S E R V I C E N O T E

HP E1655A HP75000 Series 90 ATM Analyzer

Disabling of ECLTRIG1 Line on E1405A or E1405B Command Module due to incorrect pin connection on E1672A or E1674A Transport Overhead Module.

Page 2 SERVICE NOTE E1655A-01

Figure 1

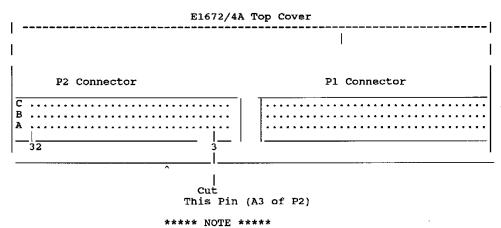
HP75000 Series 90 ATM Analyzers with Transport Overhead Modules with Serial numbers as shown above have a -5.2 volt supply incorrectly connected to pin A3 of the P2 connector of the E1672A and E1674A. This connects via the E1400B VXI Mainframe backplane to the ECLTRG1 output of the E1405A/B. This causes the ECLTRG1 output to be rendered inoperative. This will not in any way affect the operation of the Series 90 ATM Analyzers with E1691/2A with firmware revisions A.01.00 or A.01.01 but will affect future upgrades of the E1655A and any VXI modules which use the ECLTRG1 output and are used in the same mainframe as the Series 90.

Using the cutters recommended, clip pin A3 of the P2 connector on the E1672/4A module, off at the connector base so that it cannot make contact with the corresponding socket in the mainframe backplane. Be sure to capture the off cut of the pin to ensure that it cannot cause damage.

Refer to figure 1 below to locate the correct pin.

Cut pin A3 of P2 with due care. Be careful not to bend adjacent pins
